REMARKS

I. Drawings

FIG. 6

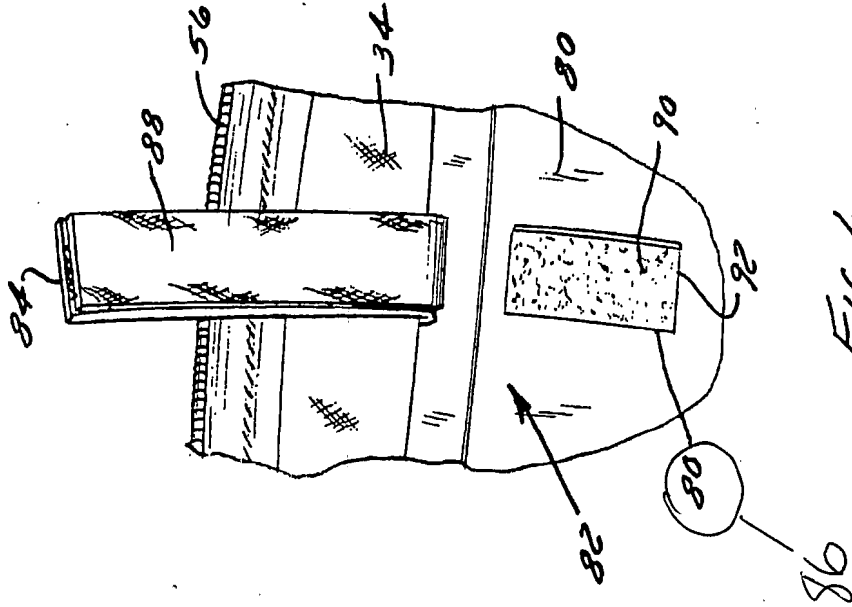
The Examiner has objected to the Drawings for failing to comply with 37 C.F.R. 1.84 because:

- 1) They do not include the reference sign mentioned in the description (a) "latch receiver 86" first recited on page 7 of 17, line 17. In response, Applicant has amended Fig. 6 and included an Annotated and Replacement Sheet 5 to include reference number 86.
- 2) Reference characters "110" and "114" shown in Figs. 8 and 9 have both been used to designate "binder anchors". In response Applicant has amended Fig. 8 and included an Annotated and Replacement sheet 7 to .
- 3) The "paper straightening structure" recited in claims 26 and 27 must be shown and/or indexed or the features canceled from the claims. In response, Applicant states that the "paper straightening structure" is the linear, (not curved) portion of the binder rings denoted by reference number 76 in Fig 4.
Reconsideration is requested.
